Work Order ID 93546

Item Name: Crosstube Turning Detail

DART AEROSPACE LTD		Work Order: 93546
Description: Crosstube Assembly (205/212/412 High Fwd)		Part Number: D212-664-141
Inspection Dwg: D212-664-141 Rev: D		Page 1 of 2

DRAWING NO. D212-664-141	TITLE XTUBE ASSY (205/212/412 HI FWD)	REV. D	DART AEROSPACE LTD ENGINEERING ORDER		D.E.O. NO. D212-664-141-D-1	SHEET NO. SHEET 1 OF 2	SCALE NTS
DRAWN	CHECKED	MFG. APPR.	APPROVED	DE APPR.			
DATE 11.04.07	DATE 11.04.11	DATE 11.04.12	DATE 11/04/12	DATE 11.04.12

**D212-664-141/-141B
ASSEMBLY DETAIL**

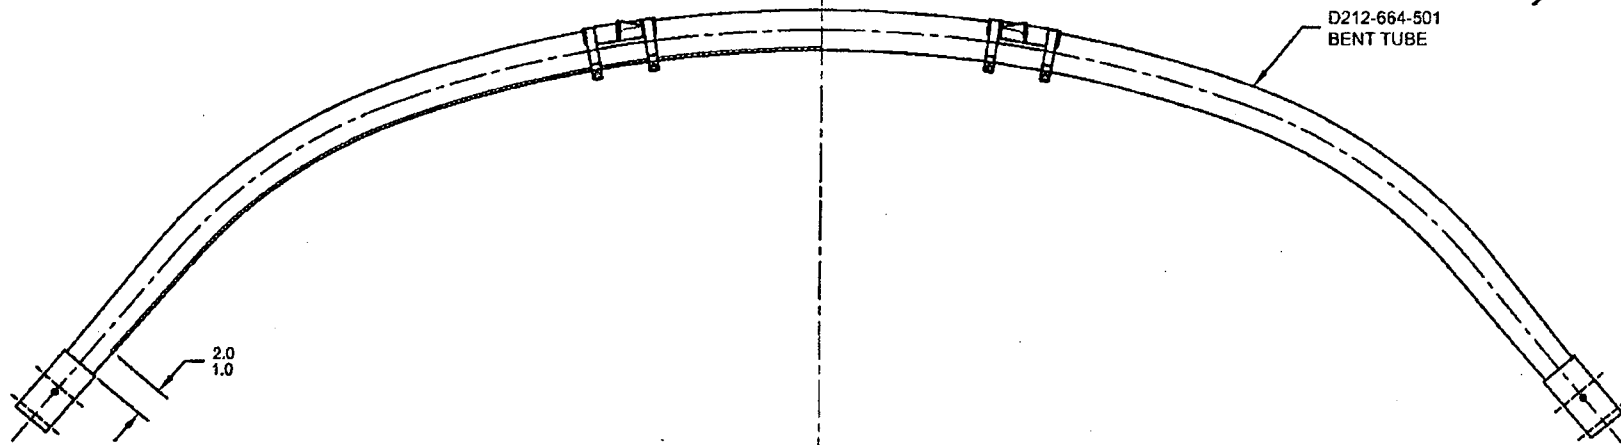
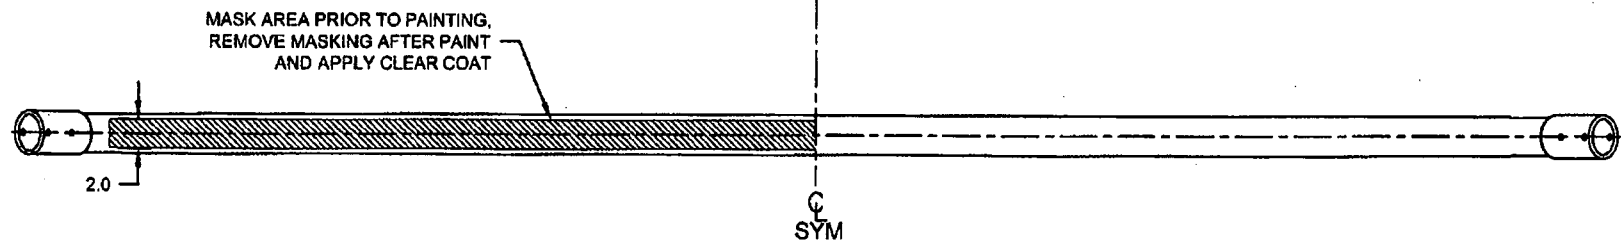
PURPOSE:

ADD AN INSPECTION WINDOW TO UNDERSIDE OF CROSSTUBE.

NOTES 2 OF SHEET 1 IS AMENDED AS FOLLOWS:

IS:

- 2) FINISH: CHEMICAL CONVERSION COAT PER DART QSI 005 4.1
PRIME INSIDE AND OUTSIDE PER DART QSI 005 4.2
MASK UNDERSIDE OF CROSSTUBE AS SHOWN (HATCHED AREA) AND
PAINT OUTSIDE PER DART QSI 005 4.2
REMOVE MASKING AND APPLY CLEAR COAT

WAS:

- 2) FINISH: CHEMICAL CONVERSION COAT PER DART QSI 005 4.1
PRIME INSIDE AND OUTSIDE PER DART QSI 005 4.2
PAINT OUTSIDE PER DART QSI 005 4.2
